312 Central Way
Design Response Package #2
Date: July 16th, 2018
DRB File #: DRV18-00317

312 Central Way | Design Response Application #2 | July 16, 2018 | Project # DRV18-00317

MATERIAL STUDY
EAST SIDE

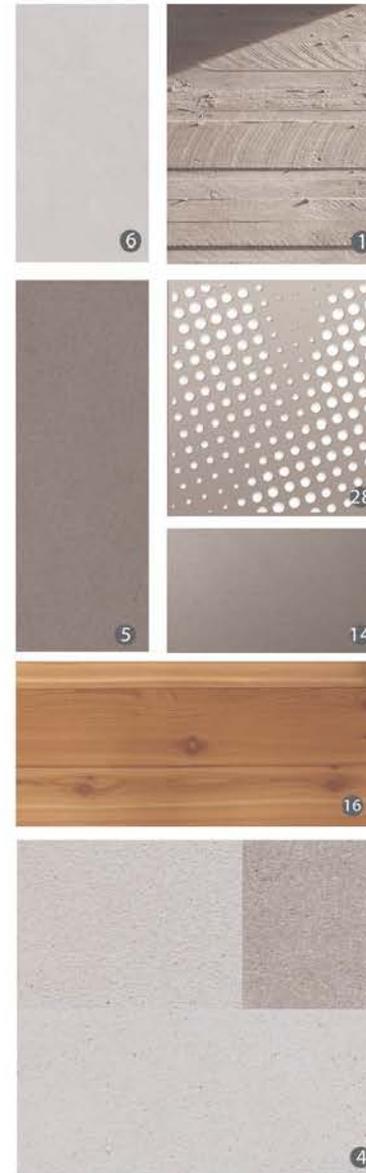
Provide renderings that clearly show materials, textures and colors. Ensure that building's colors do not make the building look "homogenous."

- ① Board form concrete
- ④ Light concrete panels with varied hues and textures
- ⑤ Concrete panel dark accent
- ⑥ Light concrete panel
- ⑭ Metal canopies and balconies
- ⑯ Wood soffits under canopies to provide visual warmth
- ⑳ Perforated metal privacy screen

ROOF TOP SCHEME - PREFERRED

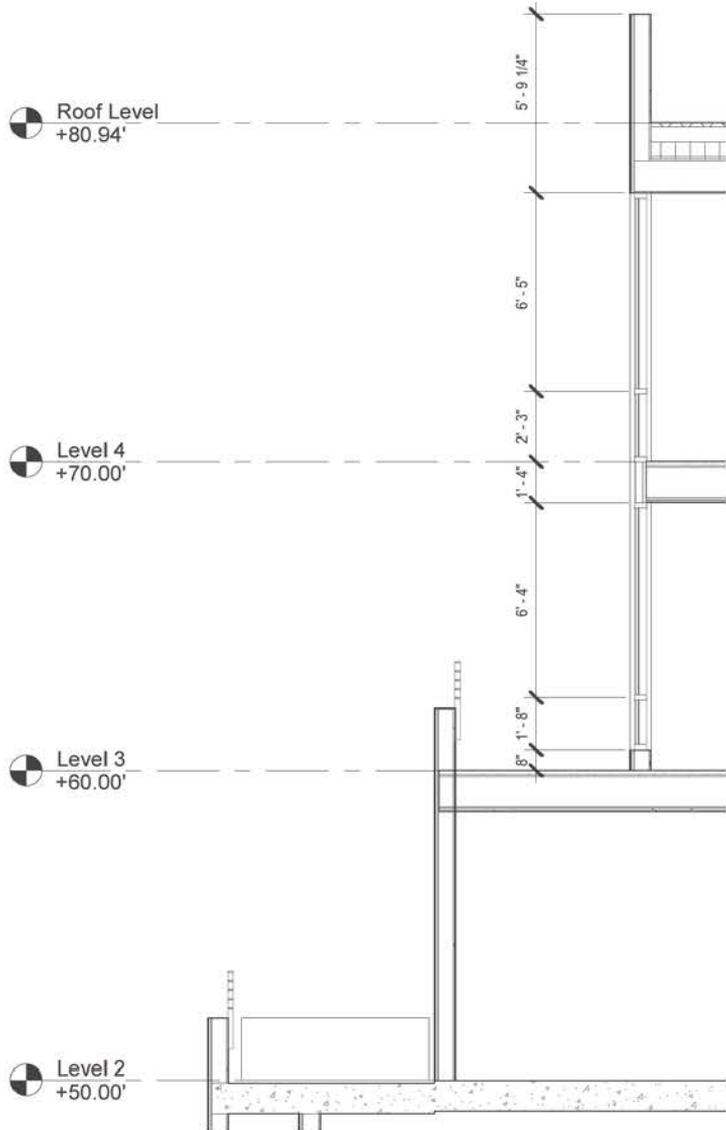
Include more detailed 3D information depicting the extent of the roof landscape as well as mechanical equipment and solar panels. Also provide more detailed 3D and sectional information depicting the impact difference between the preferred and compliant/interim roof top schemes.

- ① Green roof with various planting in weaving pattern.
- ② Tall planting to provide visual and aural privacy.
- ③ Solar panels
- ④ Pet relief area
- ⑤ Vestibule for vertical circulation.
- ⑥ Larger roof footprint.
- ⑦ Residents' amenity space

ROOF CAP & GLAZING

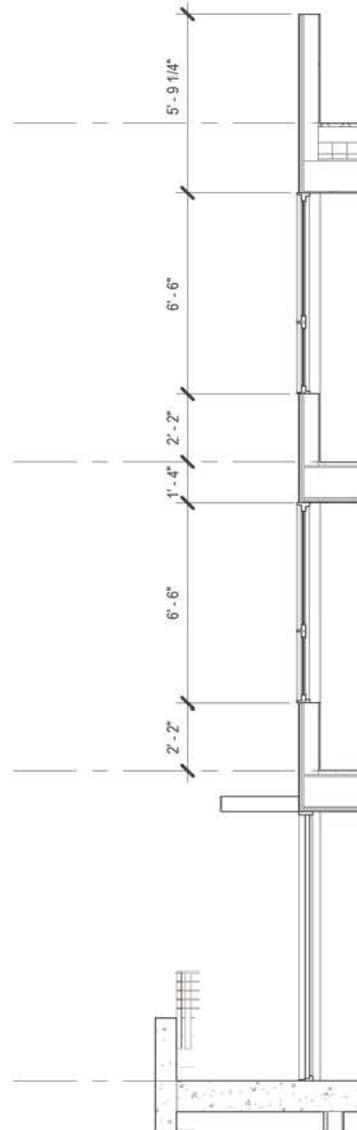
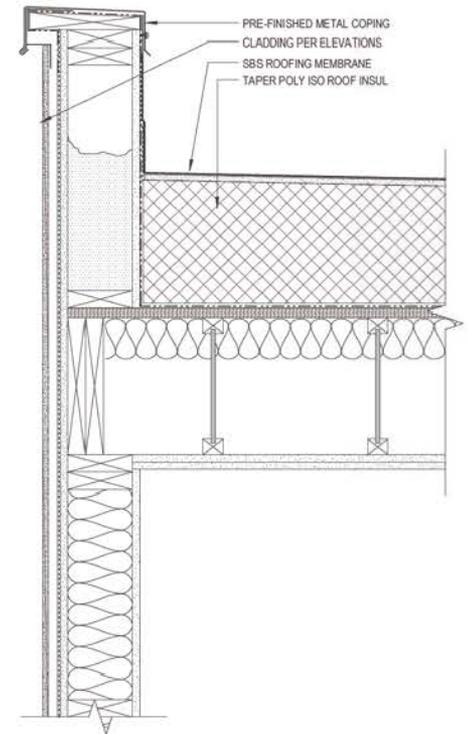
Provide roof cap details to demonstrate the project's intent.
 Provide wall sections depicting the extent of the exterior window glazing.

GROUND LEVEL PLAN WITH SPOT ELEVATIONS

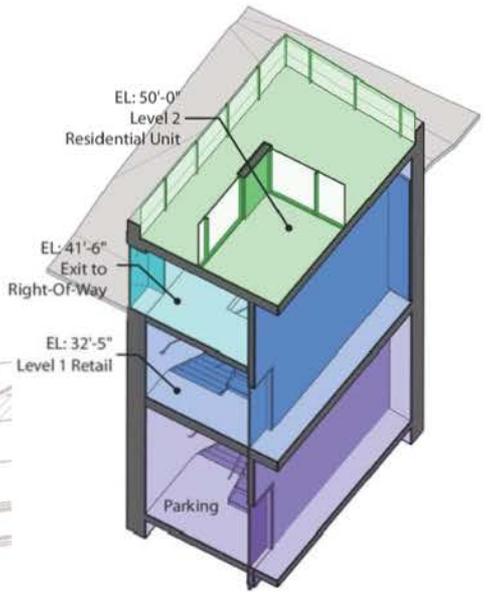
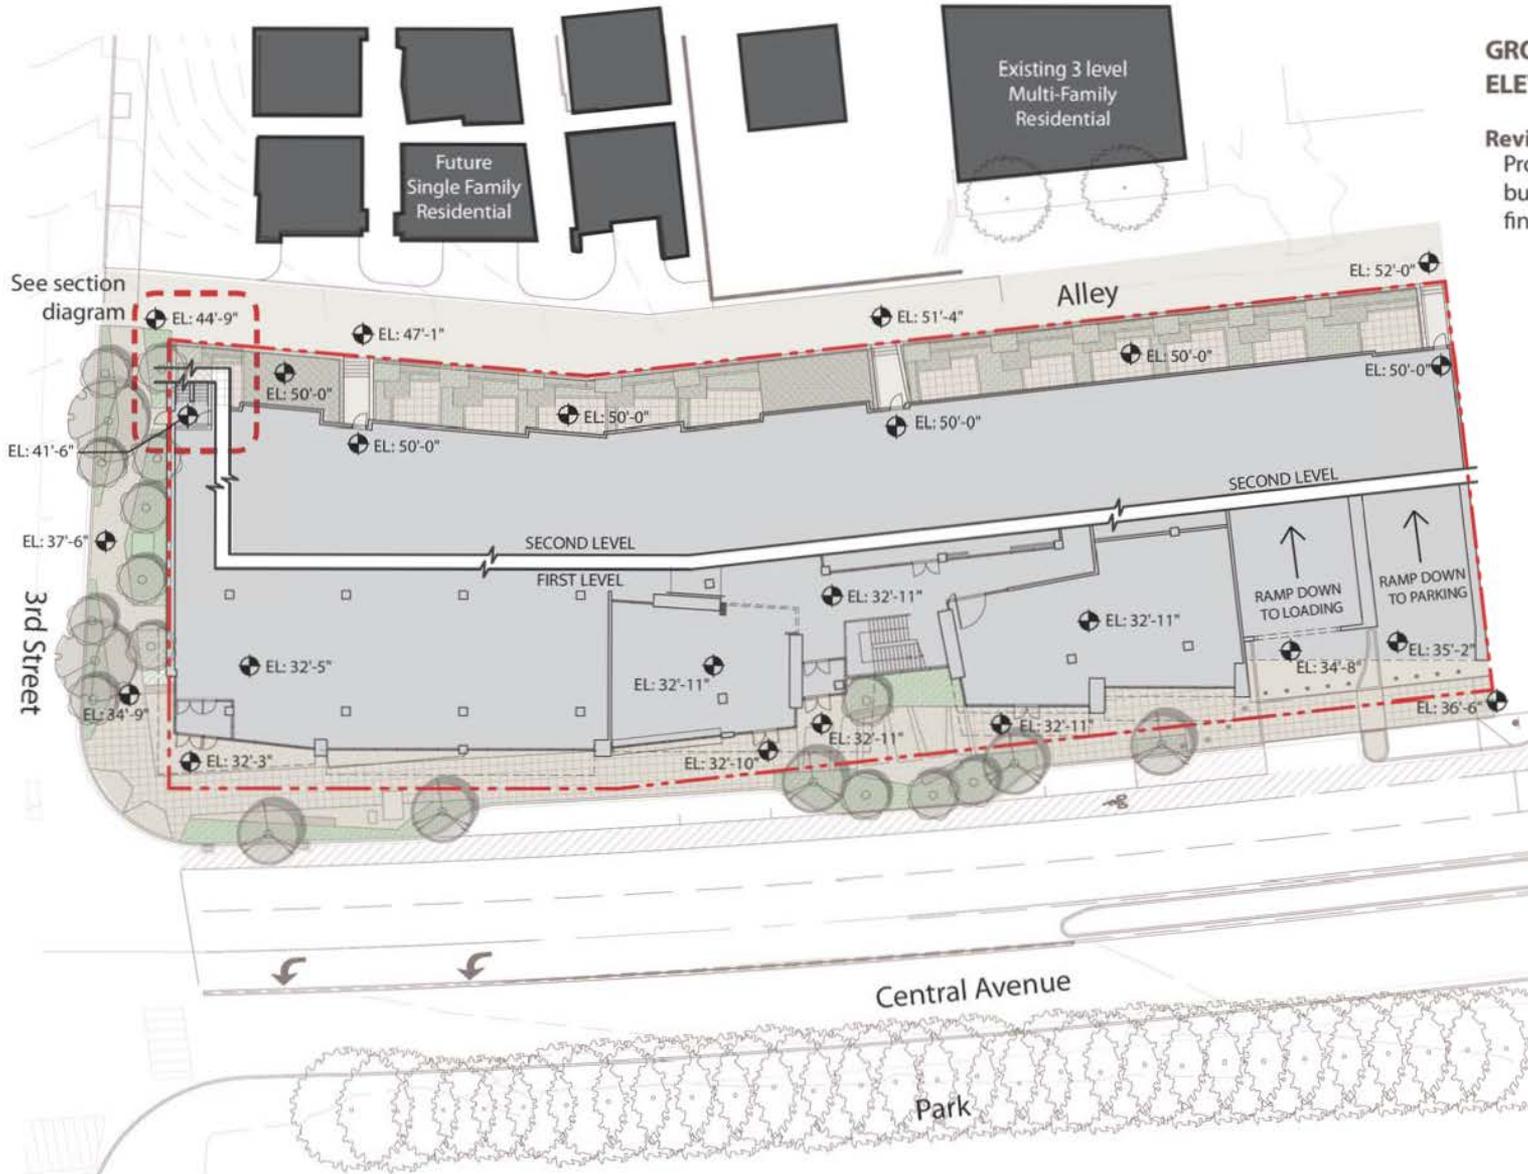
Review Board Comments:
Provide spot elevations for all sides of the building showing the relationship of building finished floor levels to exterior levels.

SETBACK ENCROACHMENT

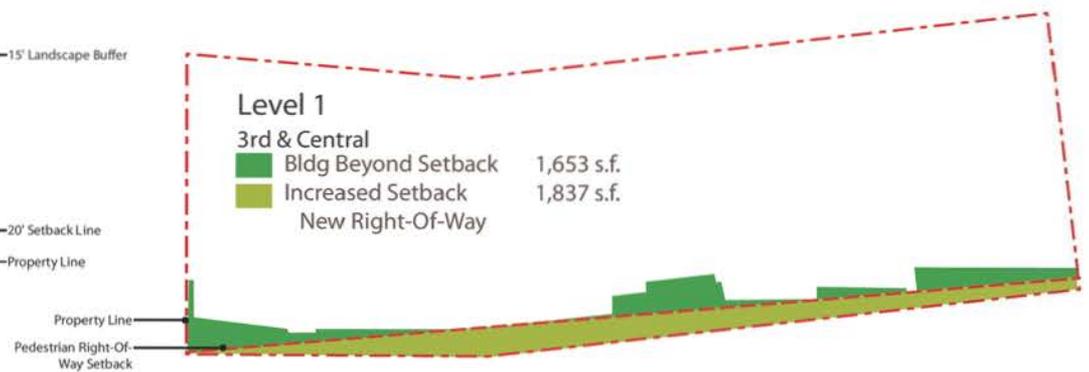
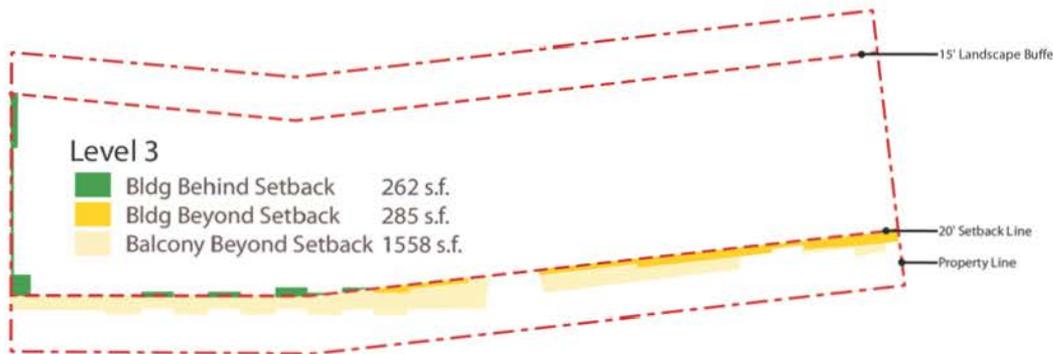
Recalculate the encroachments (including balconies) into the required setback yards for the minor variation request.

Bldg Behind Setback	675 s.f.
	Bldg Beyond Setback	2,279 s.f.
	Balcony Beyond Setback	2,175 s.f.
	Increased Setback	1,837 s.f.

**Net Building Area:
Inside Setbacks 233 s.f.**

**Net Building + Balcony Area:
Outside Setbacks 1,942 s.f.**
